ADDENDUM NO. 1

RE: City of Texarkana, Arkansas
2024 Street Rehabilitation
Bid Date: July 9, 2024 at 2PM

ADDENDUM DATE: July 1, 2024

The Plans, Specifications and Contract Documents for the above referenced project are hereby modified as follows:

STREET REPAIR SECTION AT CULVERTS

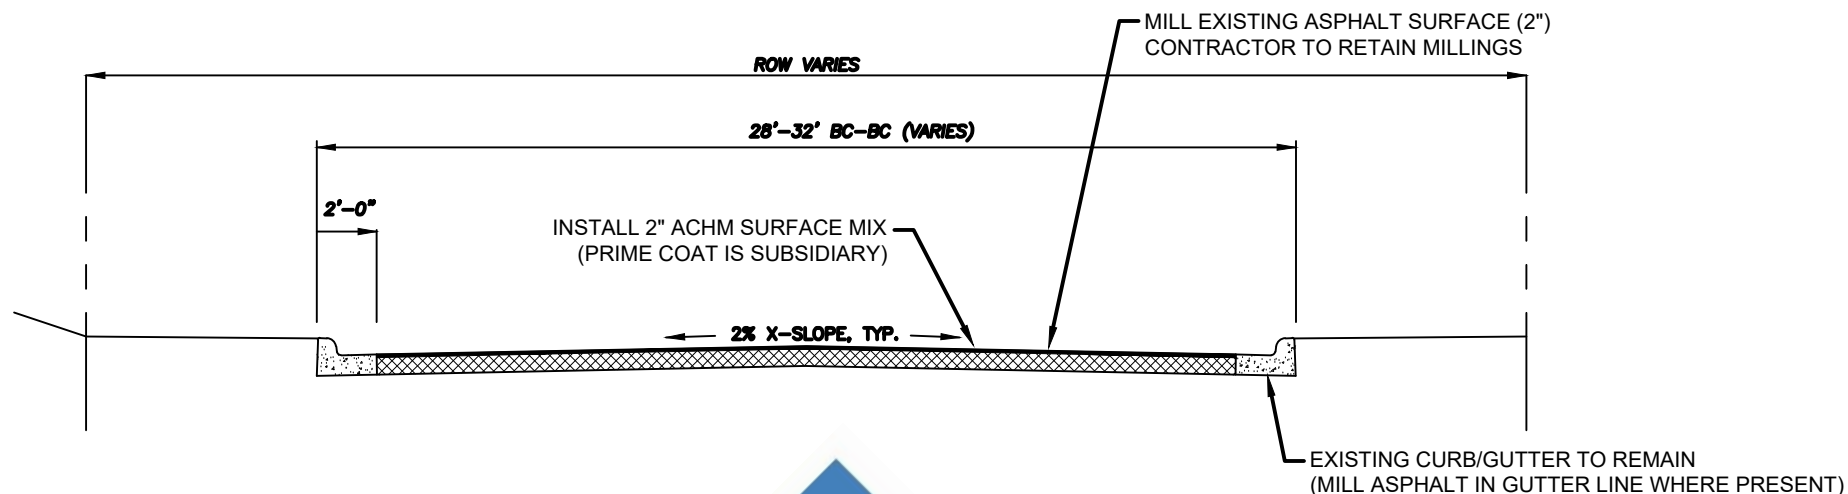
The design plans are attached and include minor scope changes that may include ditch grading, driveway transitions, culvert replacement, etc. As noted in the plans, all culvert installations shall include crushed stone backfill and NOT flowable fill.

1. PAVEMENT SHALL BE 2" THICK ACHM SURFACE PG 64-22, 12.5 MM MIX. PRIME COAT IS SUBSIDIARY. REFER TO AHTD SPECIFICATION 407.
2. SAW CUT CLEAN EDGE ON EACH END OF PAVEMENT FOR CULVERT REPL.
3. CULVERT TRENCH SHALL BE 6" LARGER ON EACH SIDE FROM THE PIPE O.D.
4. CLASS 7 CRUSHED STONE SHALL BE UTILIZED FOR BACKFILL FOR CULVERT INSTALLATIONS, TYP.
